SHED DEVELOPMENT SUBDIVISION

APPLICATION NUMBER 14 DATE January 15, 2015

REQUEST Subdivision

DETAIL SITE PLAN

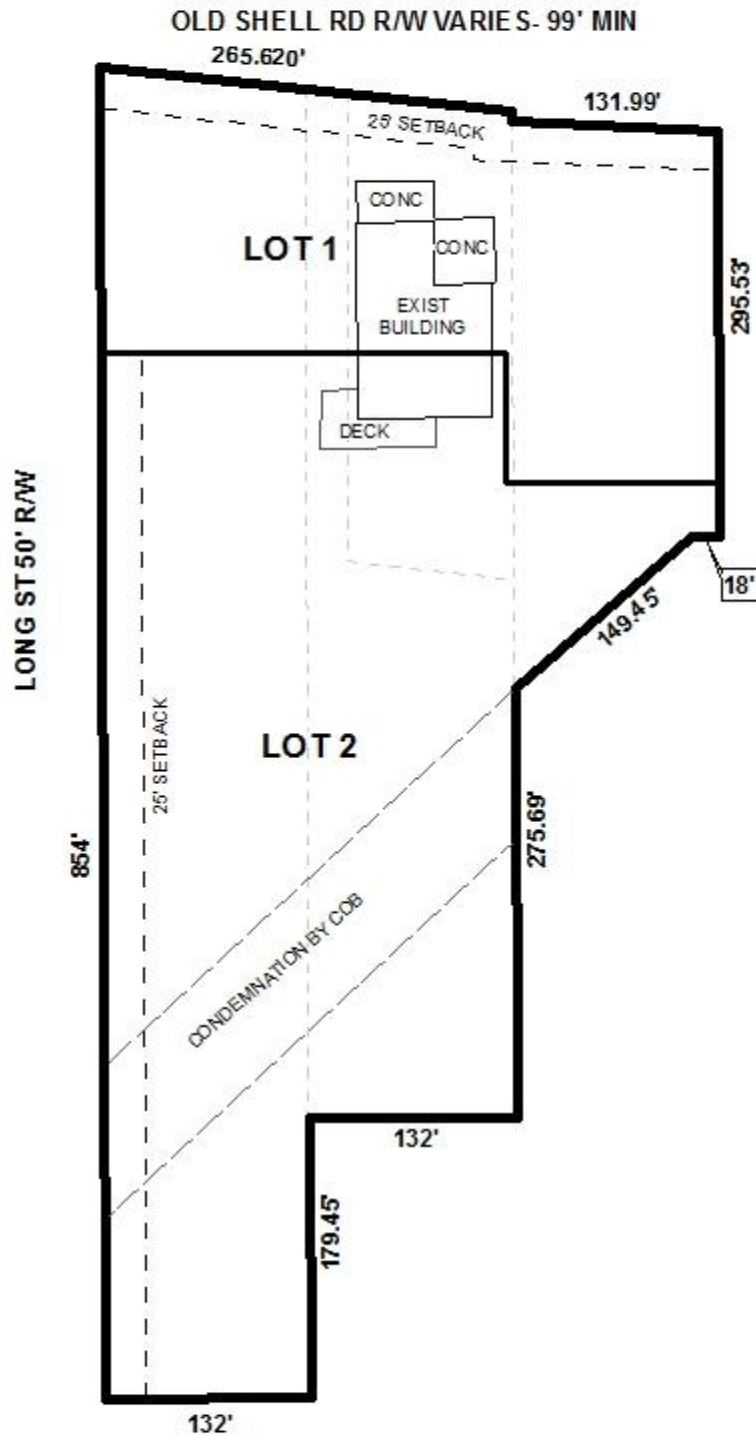
- E. Provide a written legal description or written clarification of the proposed boundary that matches the bearing and distance labels.
- F. Correct the N-S distance label from the POC to Parcel A to read in feet instead of inches.

- G. Show the tie from POC to POB for each parcel A – D; and label parcel A – D.
- H. Show and label all flood zones.
- I. Show and label the MFFE (Minimum Finished Floor Elevation) on each lot that contains an AE, V, or X (shaded) flood zone designation.

In accordance with the Subdivision Regulations, both proposed lots are compliant with the minimum size requirements. The 25' minimum building setback line and lot size information is illustrated on the preliminary plat and should be retained on the Final Plat, if approved.

The proposed subdivision site abuts two adjacent, undeveloped landlocked parcels. It appears that each of the landlocked parcels abut property to the east which is under ownership by the same family or corporate entities, thus access to these parcels should not be required through this request.

The site fronts Old Shell Road and Long Street. Old Shell Road is a component of the Major Street Plan, and due to the recent right-of-way acquisition and widening, no addition right-of-way is required. Long Street is a substandard minor street in terms of width and level of improvement, and is labelled with a 50' right-of-way width along this street. As this street is substandard, it should be improved along the entire property frontage on the north side of 12 Mile Creek at the time of development of each lot. The applicant should verify the right-of-way width along this street with the Engineering Department and, if the right-of-way width is not sufficient, dedication along Long Street, sufficient to provide 25' from centerline, should be required. The provision of a corner radius in compliance with Section V.D.6. of the Subdivision Regulations should be required at the southeast corner of Long Street and Old Shell Road. The

It should be pointed out that large power lines are present along Long Street which may mean there is an easement not shown on the preliminary plat. If necessary, the Final Plat should be revised to illustrate all easements along with a note stating no permanent structures can be placed or erected within any easement, if approved.

GIS data depicts the western portion of the site within a Floodway as well as the AE and X-Shaded Flood Zones associated with Twelve Mile Creek. The proximity of the site to water may mean that the site is environmentally sensitive, thus approvals from local, state and federal agencies for wetland and floodplain issues may be required prior to development. A note regarding these requirements should appear on the Final Plat, if approved.

- 1) Provision of a corner radius at the southeast corner of Old Shell Road and Long Street, in compliance with Section V. D.6. of the Subdivision Regulations;

- 2) Dedication along Long Street, sufficient to provide 25' as measured from centerline, if necessary;
- 3) Long Street should be improved to City of Mobile standards at the time of development of each lot;

- 4) Revision of the lot size information and 25' minimum building setback line on the Final Plat to reflect any dedication;
- 5) Placement of a note on the Final Plat stating that site is limited to two curb cuts to Old Shell Road, and five curb cuts to Long Street, with the size, design and location to be approved by Traffic Engineering and conform to AASHTO standards, with all unused curb-cuts removed and replaced with landscaped material;
